New spare part and software version 3.4.3.0 for the BioSpectrometer family 613x and BioPhotometer D30 6133

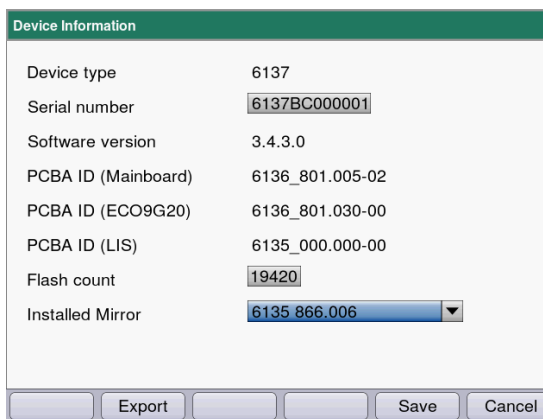
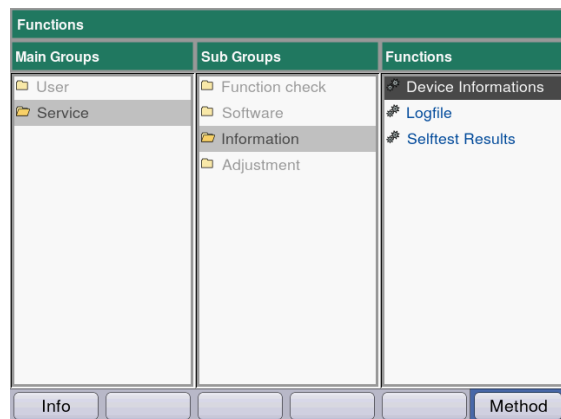
The spare part “Mirror 6135 866.006” for the BioSpectrometer family “613x” and the BioPhotometer D30 “6133” is no longer available.

The existing mirror will be taken back by Eppendorf until the end of December 2013 and replaced by a new “mirror 6135 866.103“. Please use the SIL procedure for this.

If the “mirror 6135 866.006“ is replaced, the new software version 3.4.3.0 must be installed.

In the “Device Information“ service function the article number for the installed mirror must be selected next to “Installed Mirror“. For the new mirror, activate 6135 866.103.

- When replacing the main board, these mirror parameters must also be set.
 Existing mirror: activate 6135 866.006
 New mirror: activate 6135 866.103
- After each assembly, the device must be adjusted using the “Optical Adjustment” service function.
